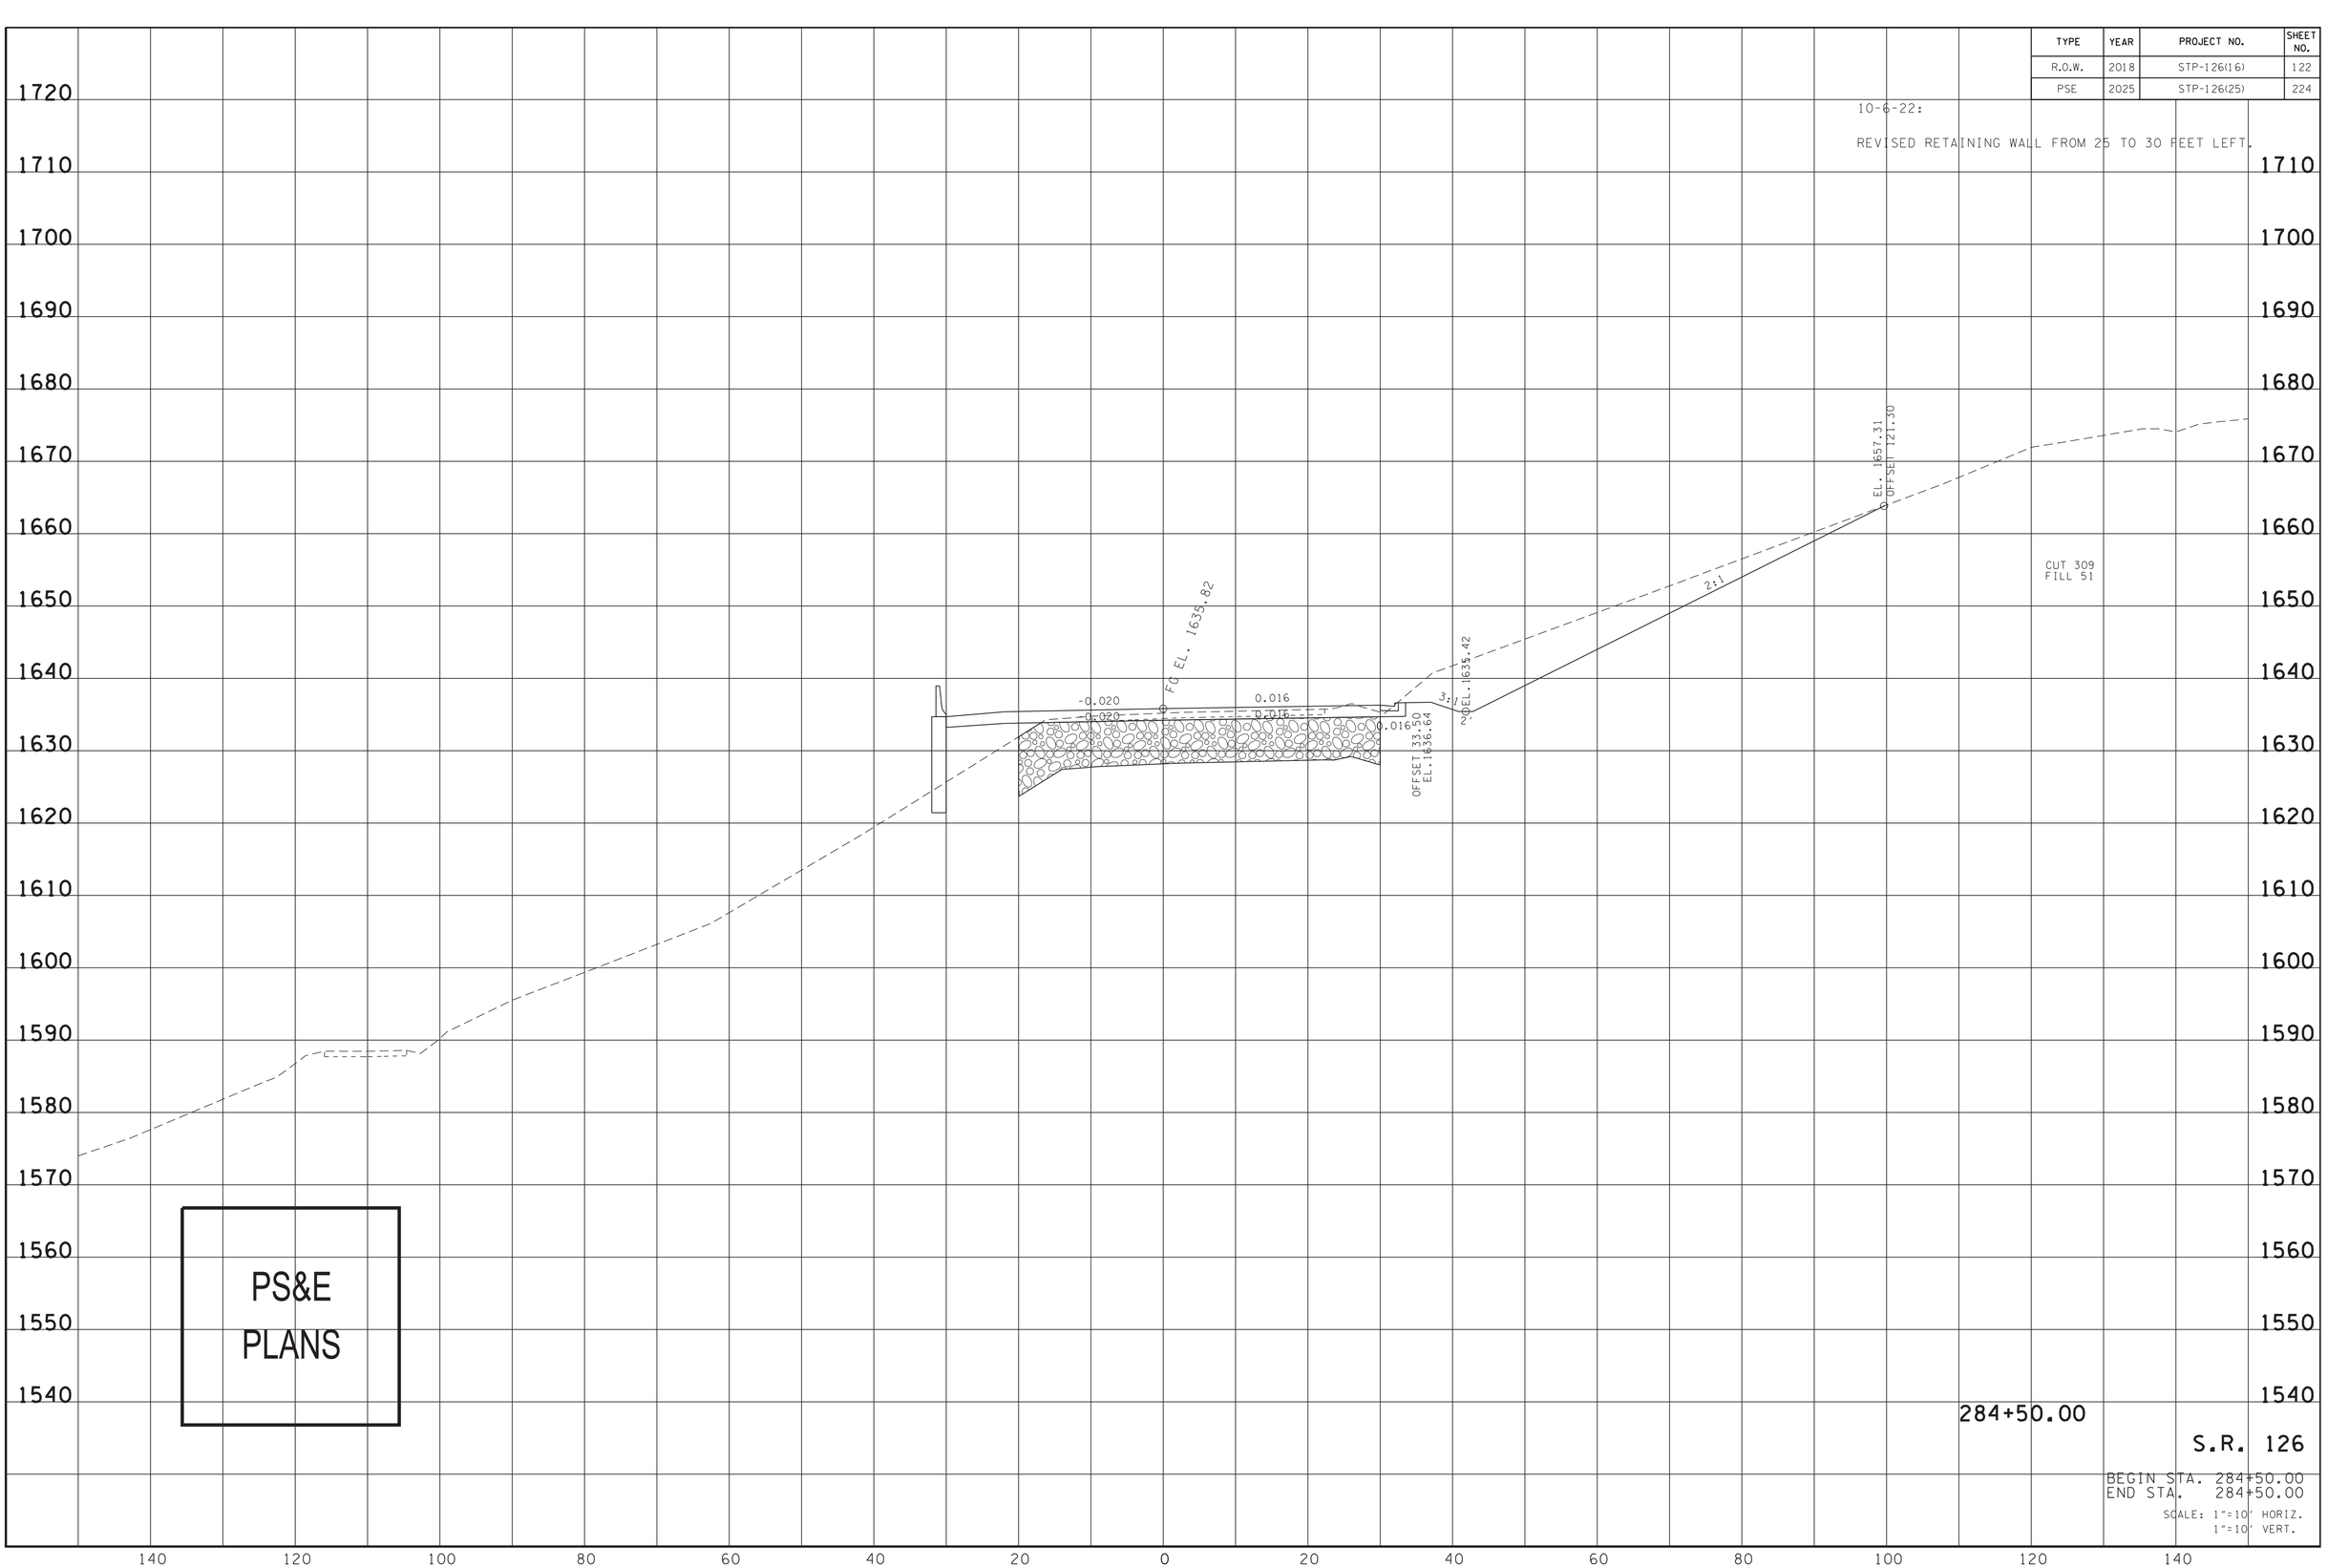
10-6-22:

REVISED RETAINING WALL FROM 25 TO 30 FEET LEFT.

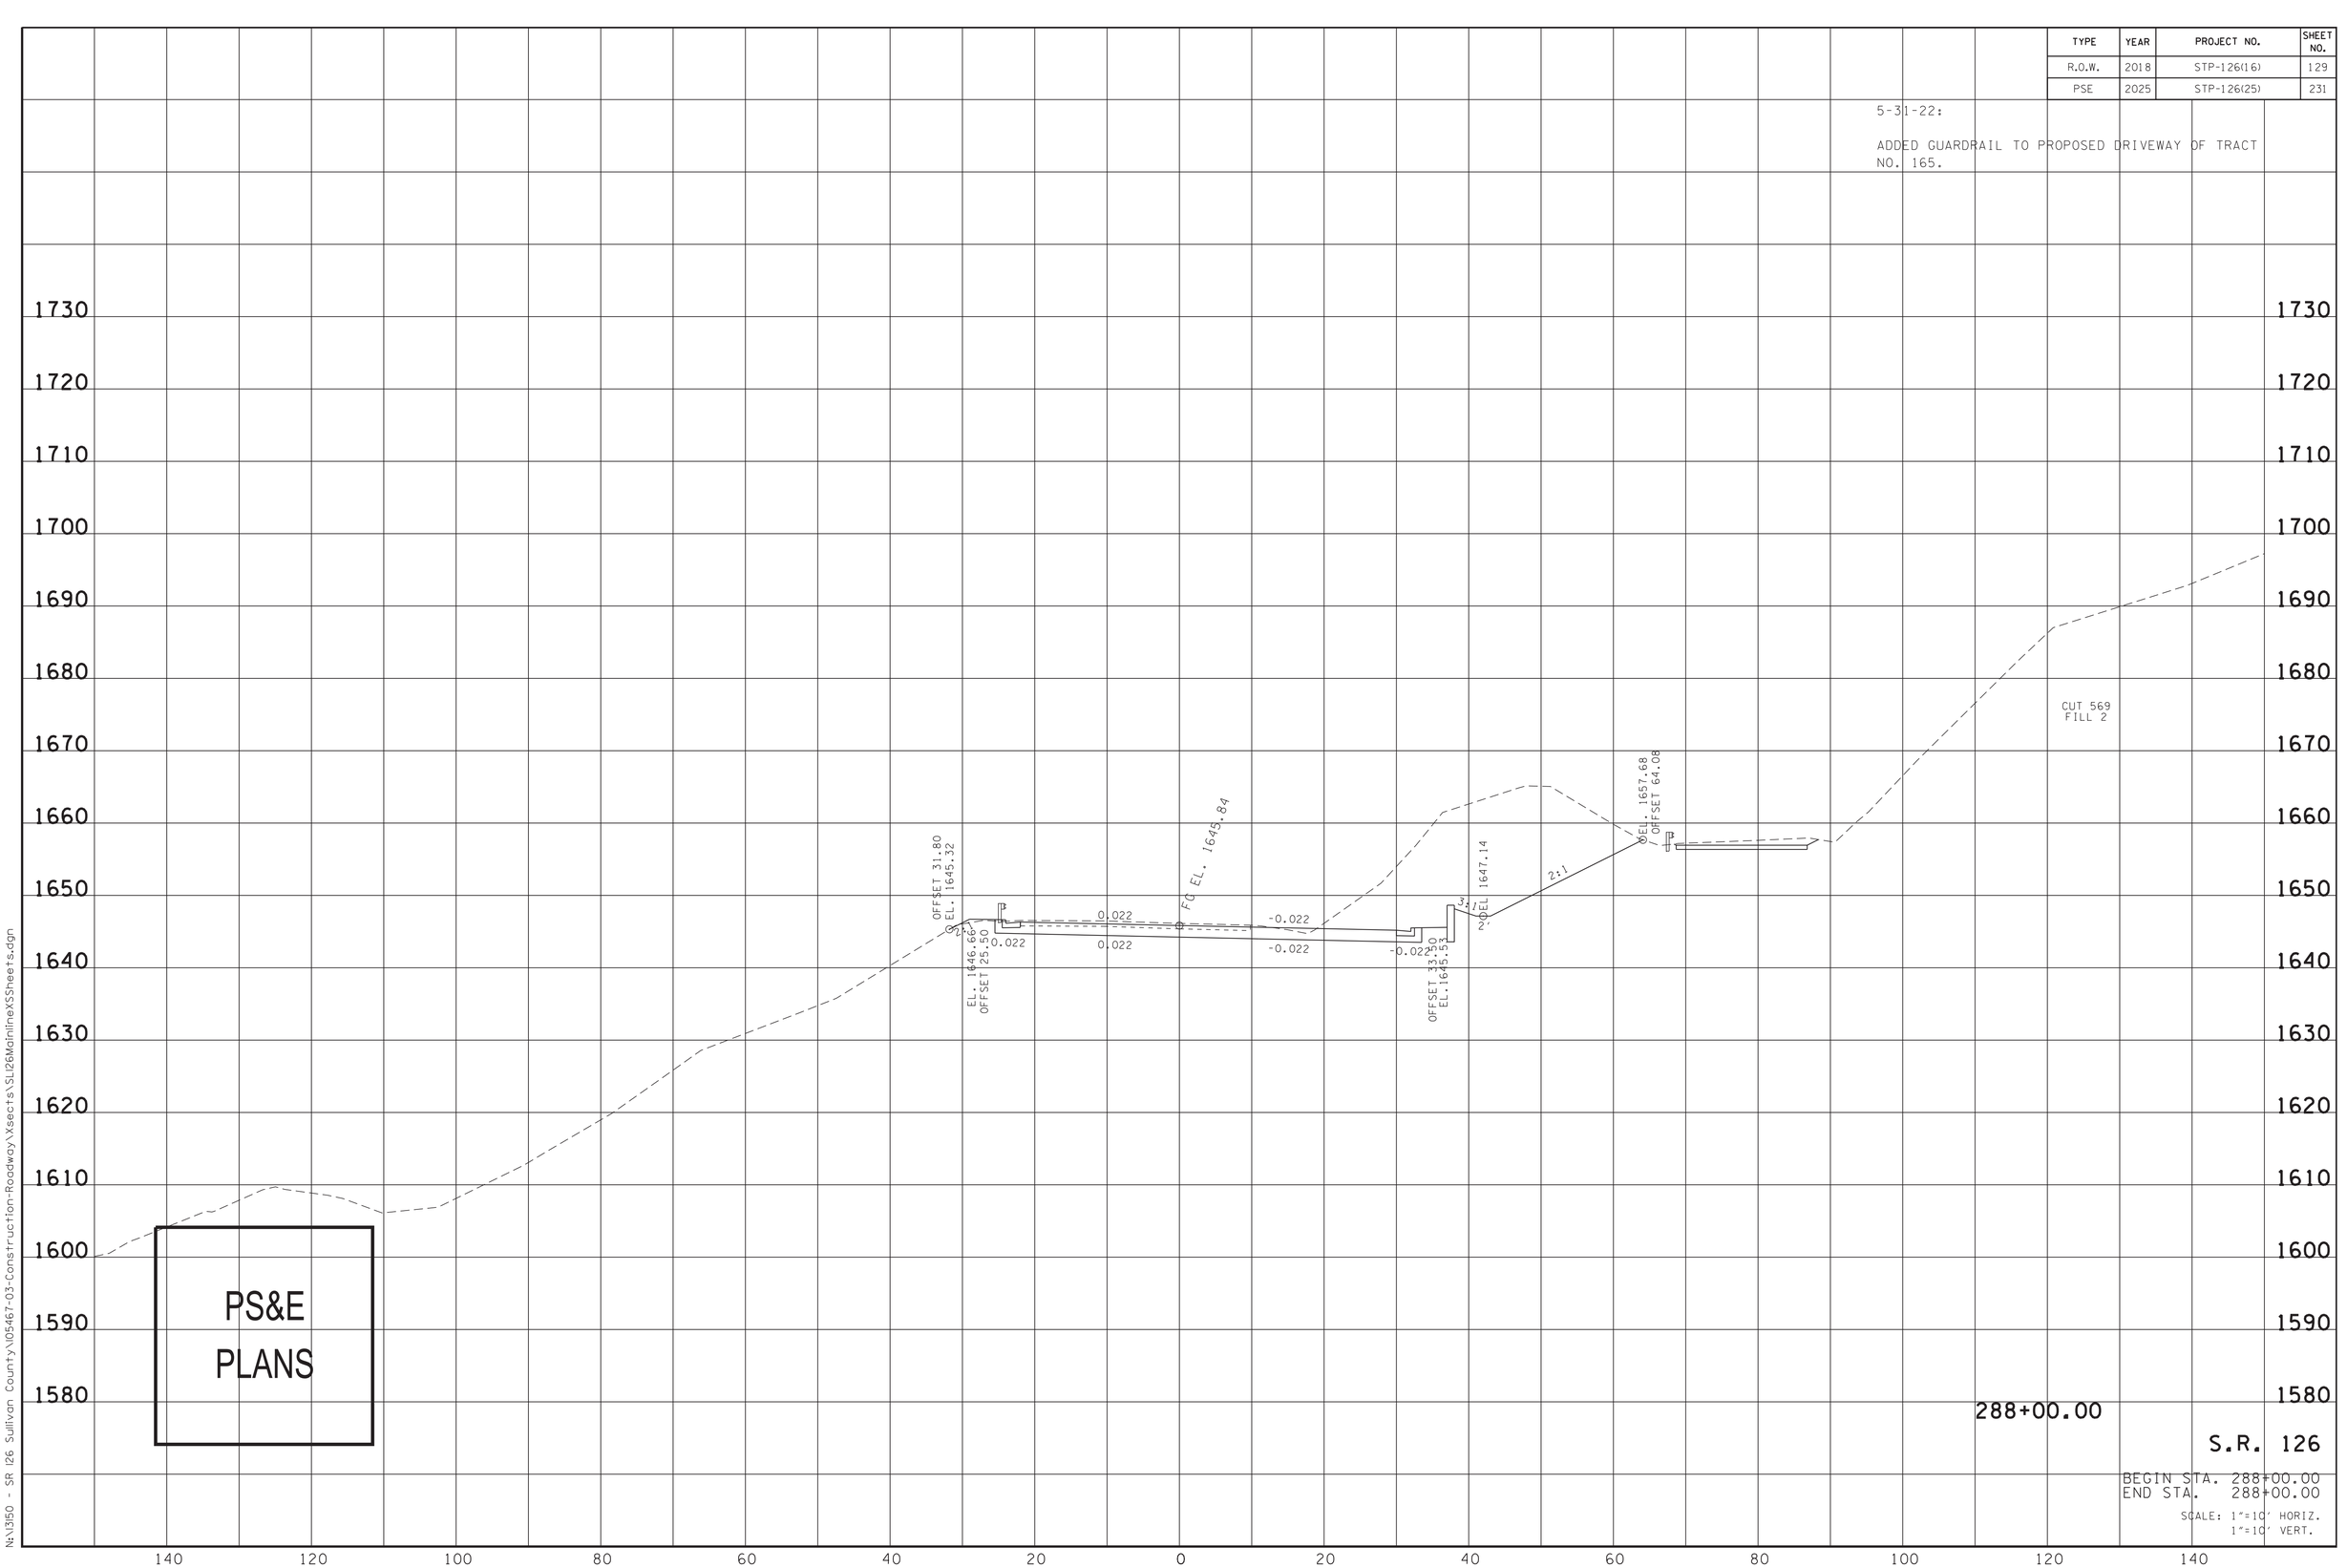
ADDED GUARDRAIL TO PROPOSED DRIVEWAY OF TRACT NO. 165.

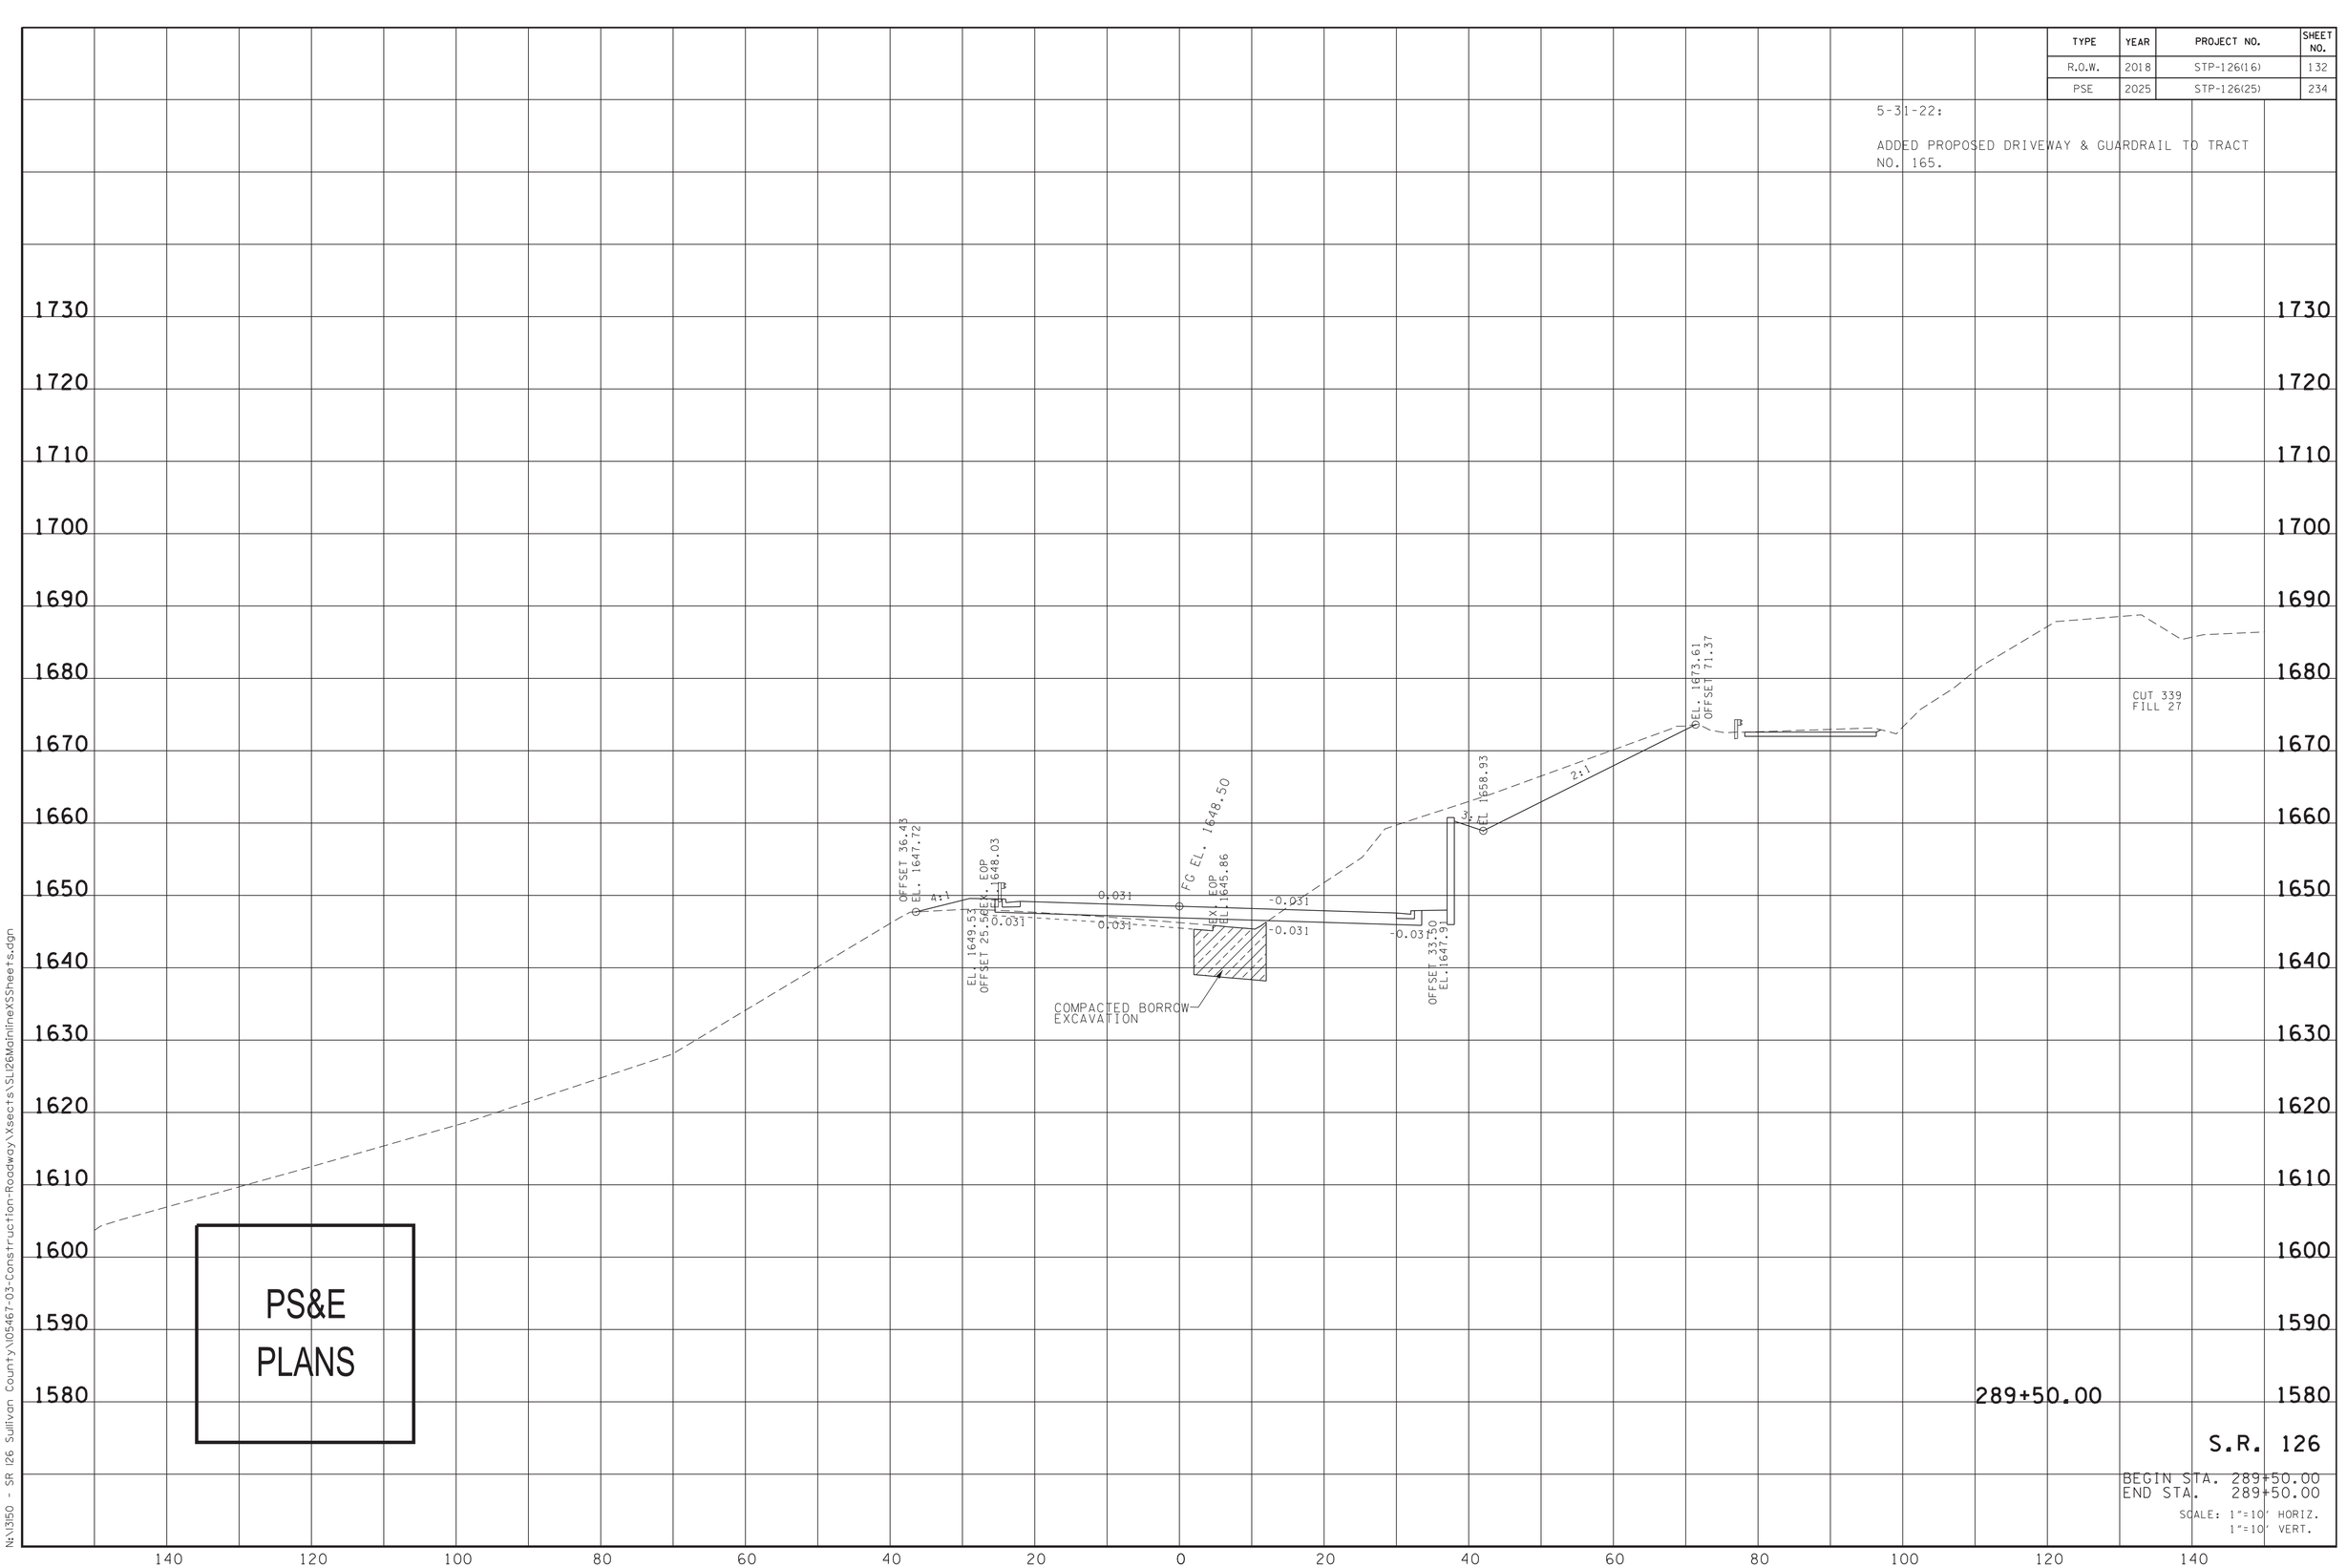
ADDED PROPOSED DRIVEWAY & GUARDRAIL TO TRACT NO. 165.
